Docket No. 52-021  
MHI Ref: UAP-HF-12126

**Subject: MHI's 3<sup>rd</sup> Amended Response to US-APWR DCD RAI No. 740-5719  
Revision 2 (SRP 06.02.02)**

**US-APWR Design Certification  
Mitsubishi Heavy Industries, Ltd.  
Docket No. 52-021**

**QUESTION NO.: 06.02.02-64**

Figure b-1 Film Condensation on Structure Surface

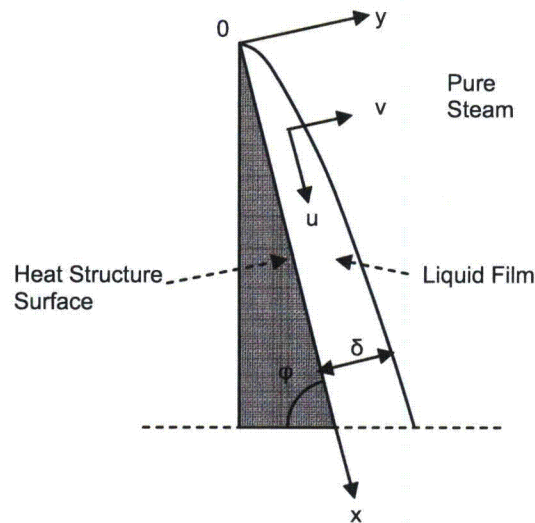
- o Condensate water on containment surfaces – Equation listed for film condensation correlation used to calculate film thickness could not be readily verified (reference in Japanese) and was not found in standard textbooks on heat and mass transfer. Appropriate reference and justification should be provided for the applied methodology and selected input values. Film thickness will be a function of the surface height. Justify estimated vertical surface area and corresponding heights used in the calculations.

Condensate film thickness was calculated from Eq. 11 in the hold-up volume calculation based on the fluid conditions. The calculation follows the methodology of theoretically solving the Nusselt film heat transfer correlation, which is widely known (References 4 and 5).

Assume constant condensation and liquid flow on structure surfaces (Figure b-1).

Condensation liquid thickness on the surface of the heat structure is predicted by Eq. 11. The height used for this calculation was 40 meters (about 130 feet), and the resulting condensation film thickness (based on 40 meters height) was applied to all surfaces. The vertical portion of containment from the second floor level (EL 25'-3") is about 129 feet. If the vertical height ( $x$ ) increases, the liquid film thickness also increases as shown in Eq. 11. However, the liquid thickness calculated based on a 40 meter height was conservatively applied to all surfaces.
